Re: Claim #: 040515008195
Insured: Versatube Corporation
4755 Rochester Rd., Troy, Michigan 48085
Our File: Versatube Corp

Subject: Versatube Corp. Sheppard Report, Beam Repairs, and Codes

VERSATUBE STAMPING PLANT
INSPECTION OF FIRE DAMAGE REPAIRS
4755 ROCHESTER ROAD, TROY MI

**Re: Versatube Stamping Plant – Inspection of Repairs to Fire Damaged Structure
4755 Rochester Road Troy, MI**

Partial Roof Framing Plan & Column Top Details
Versatube, 4755 Rochester Rd., Troy, MI
for **Belfor**

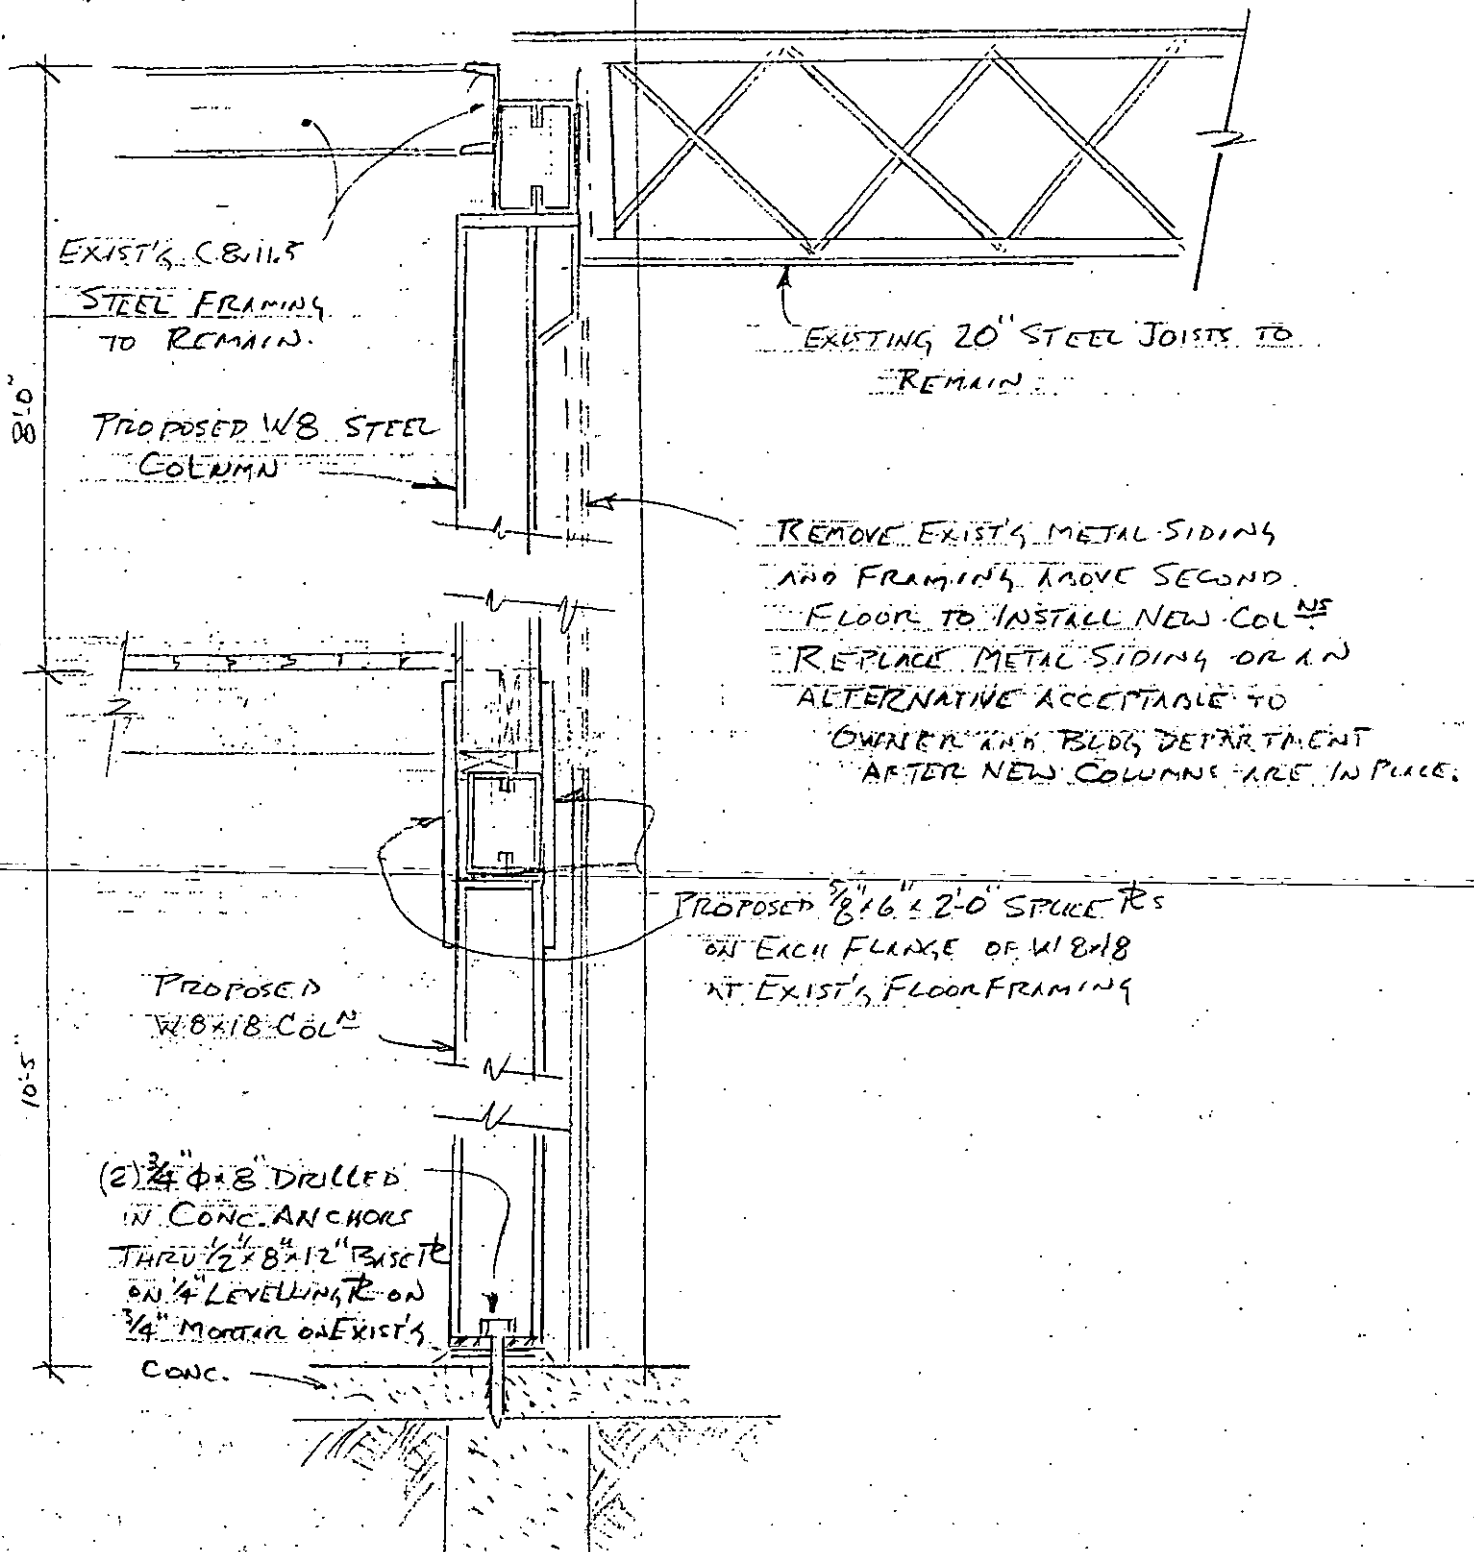
4. (4/15/15) Sketches prepared do not accurately reflect the eccentricity of the offset beams. The actual eccentricity measured is more than indicated on the sketches.

7. (4/15/15) The sketches issued indicate an alternate approach to beam replacement without stipulating details of the structural welding connections including but not limited to:

- a. welder certification,
 - b. material certifications,
 - c. Welding Process Certification (WPC) or supportive Procedure Qualification Record (PQR),
 - d. structural welding requirements,

Partial Roof Framing Plan of Fire Damaged Area
Versatube, 4755 Rochester Road, Troy, MI
for Belfor

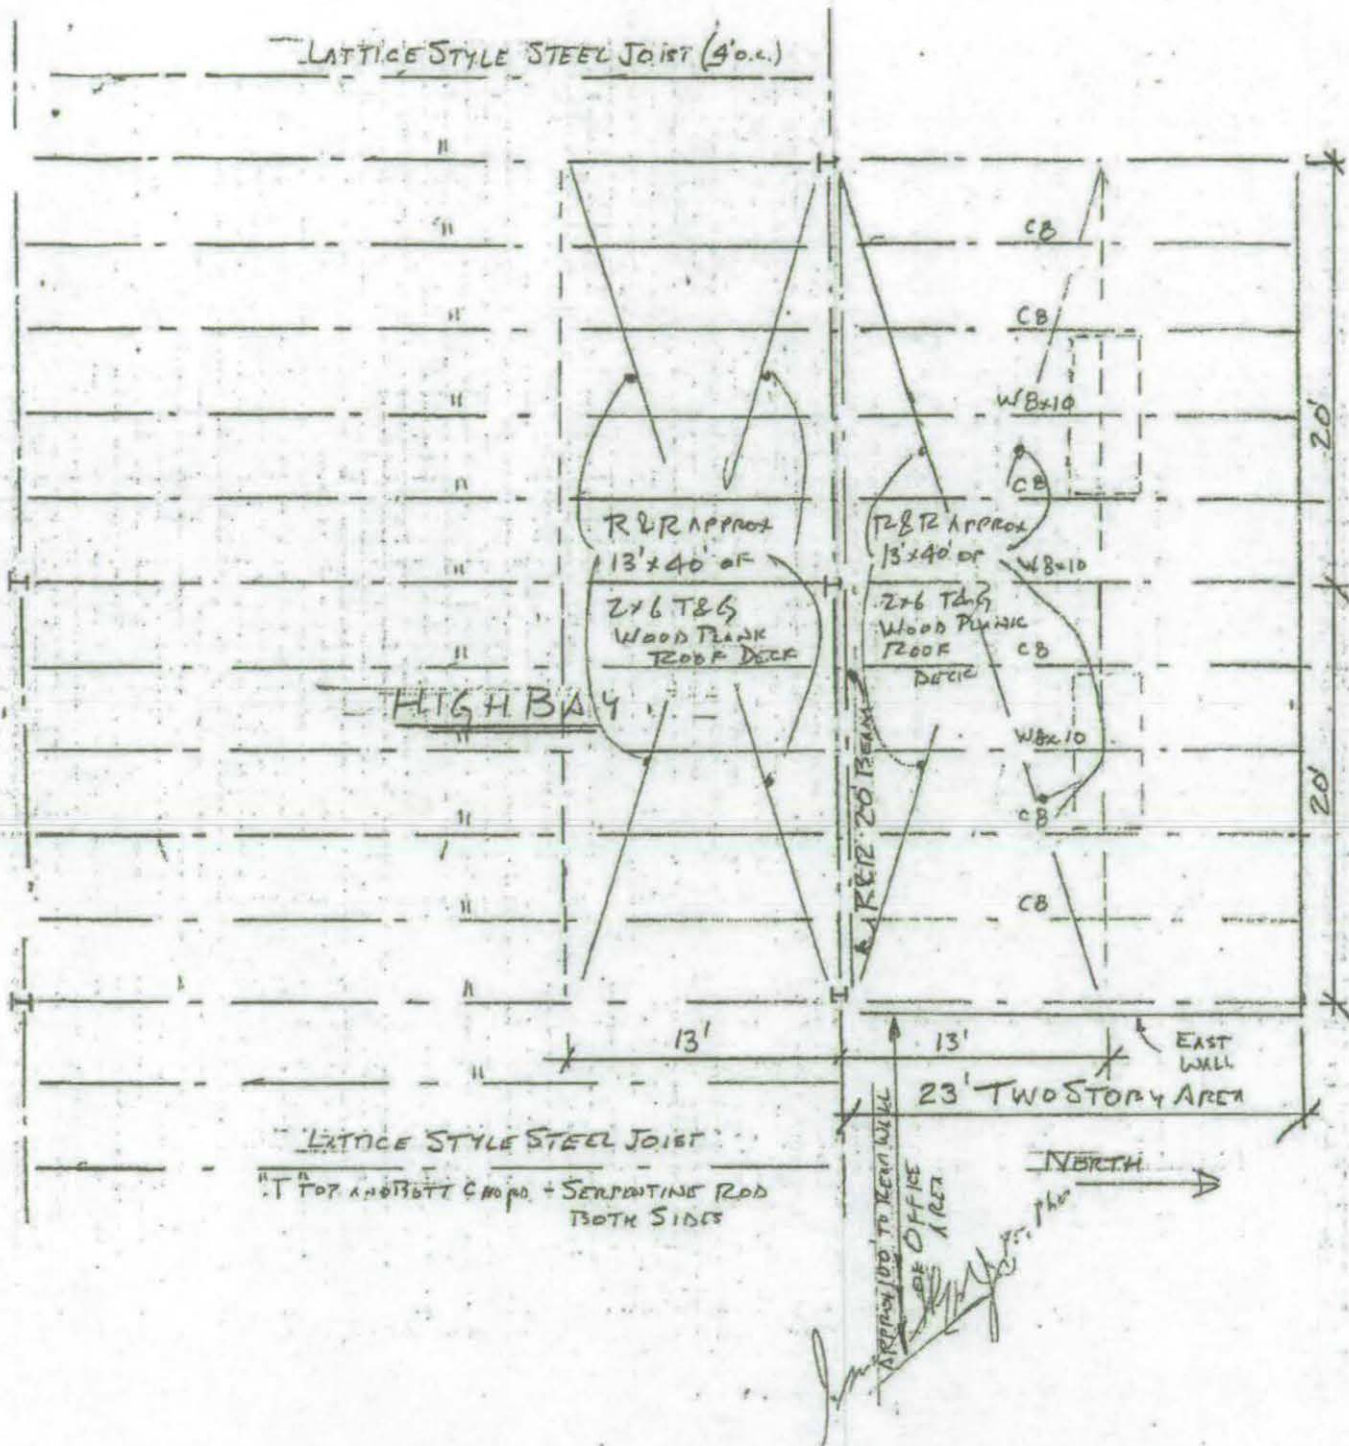
3. (2/13/15) Page 1, paragraph 3, 2nd sentence states in part; "*These channels and beams had not been structurally damaged by the fire.....*", however, I would say the twisted and bowed roof channels are in that configuration due to the fire.

9. (2/13/15), Sketches indicates a trench footing below the concrete. There is no evidence such a footing exists.
10. The anchor bolts if specified to be 3/4" diameter x 8" long. This length is insufficient to comply with the Michigan Building Code (MBC) 2009, Section 2308.6, which stipulates an embedment "*..... of at least 7 inches.....*" Therefore, the concrete anchor must be more than 11 1/2 inches long. Refer to Appendix C.

Photo #3 - South side of wall. Burned siding near floor is location of column base plates at columns added after the fire.

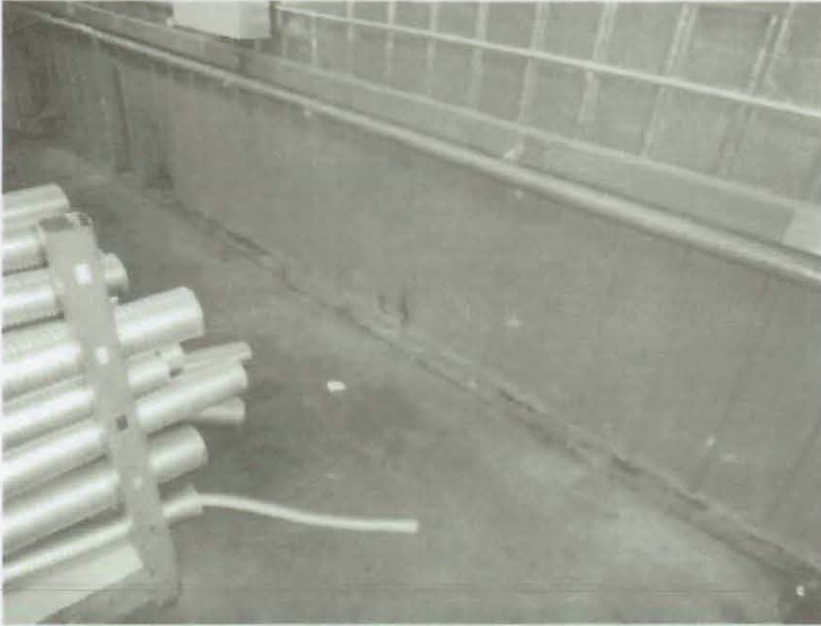
Photo #4 - South side of wall. Burned area is location of base plate of column added after fire.

Photo #5 - North side of wall at west added column looking south.

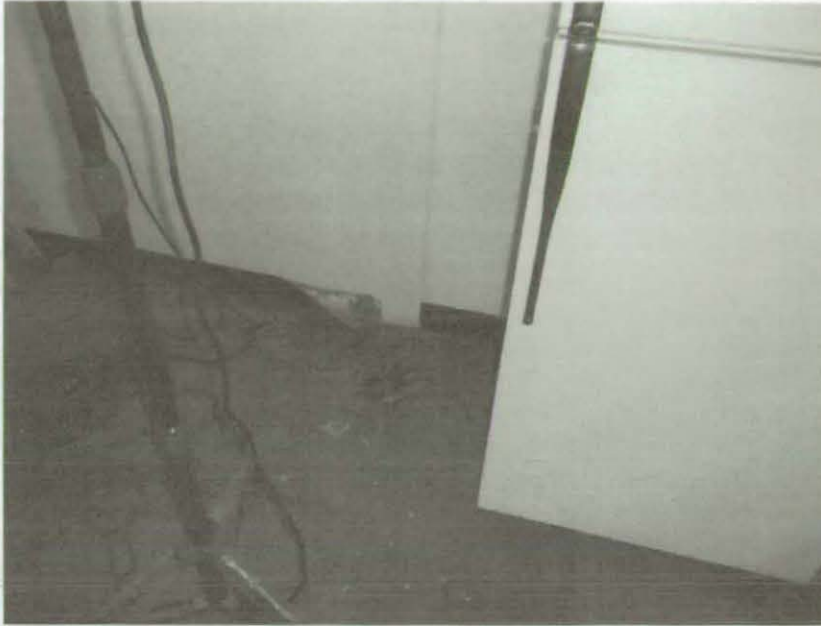
Photo #6 - West of two added columns at column splice.

Photo #8 - East added column. Close-up of saw cuts where continuous angle supporting wood second floor joist was cut. Note saw cut into existing steel beam.

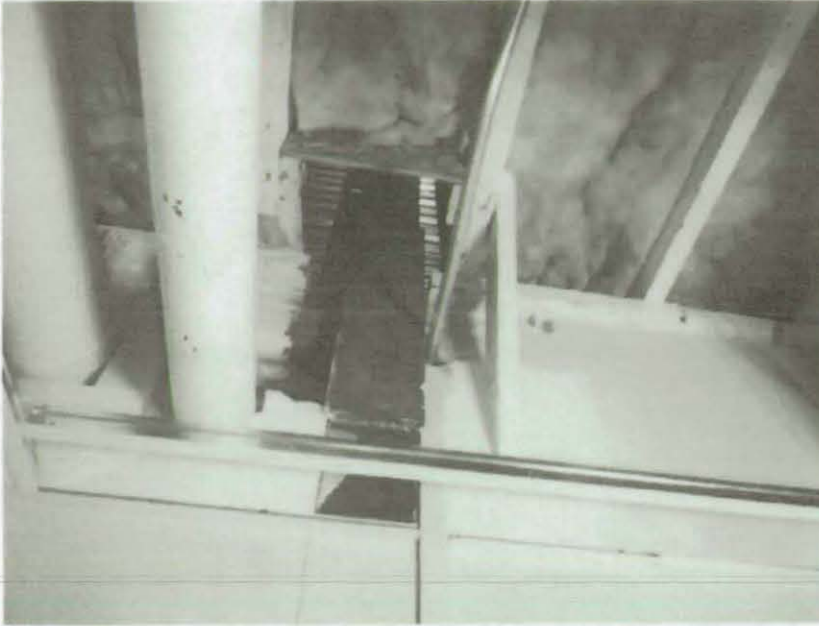
Photo #7 - East of two columns at column splice.

4. Eliminate the two added columns and repair the locations along the existing second floor beam where the saw cut into the sides of the tube. The removed section of angle ledger should be spliced back in and the saw kerfs repaired and the wood nailer supporting the second-floor joists should be spliced back together as well.

Photo #15 - West added column. Weld of bottom of 5/8" x 6" x 24" plate to flange of added column.

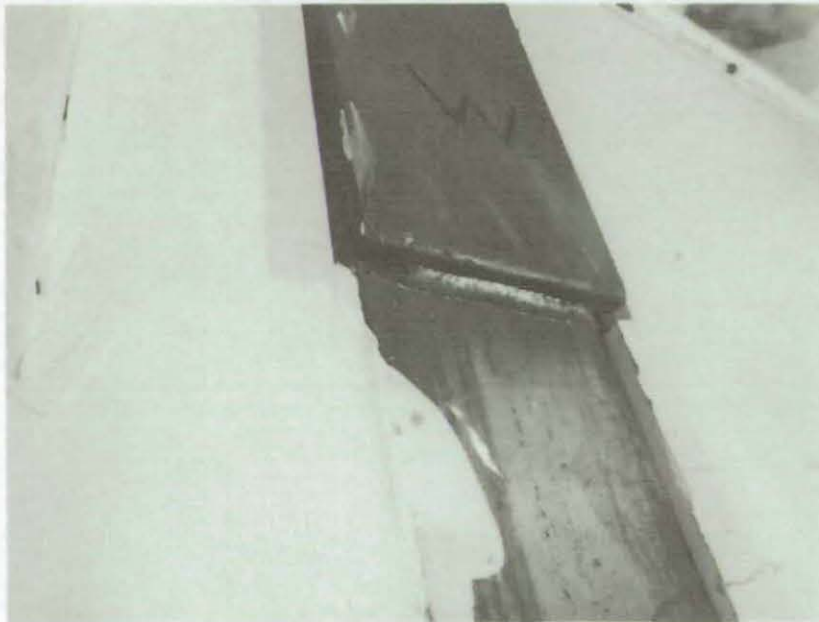
Photo #14 - Weld of tubular beam to lower half of east column looking SE.

Photo #16 - Top of west column. Note buckled flange of beam beyond.

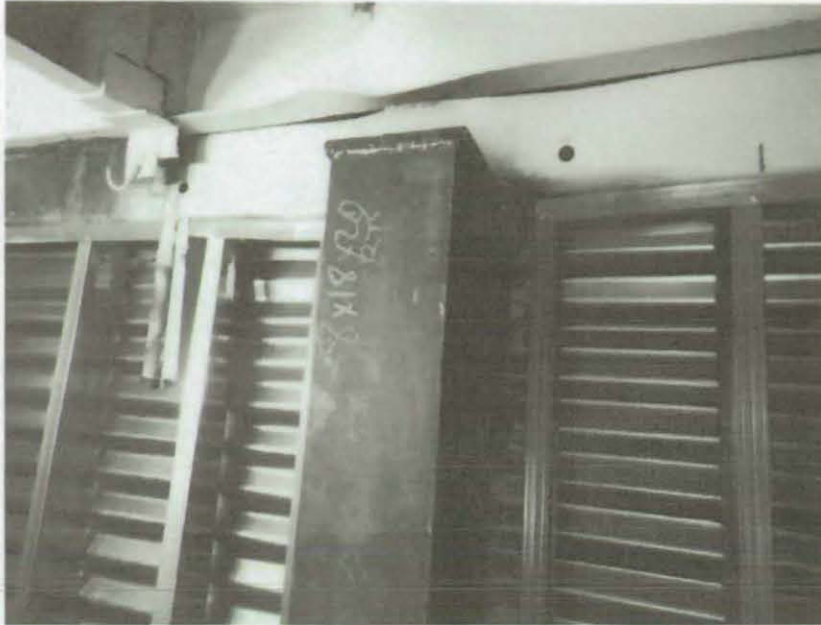
Photo #17 - Looking down at column splice of west column. Note tubular beam appears to be two tubes or two cold formed channels face to face.
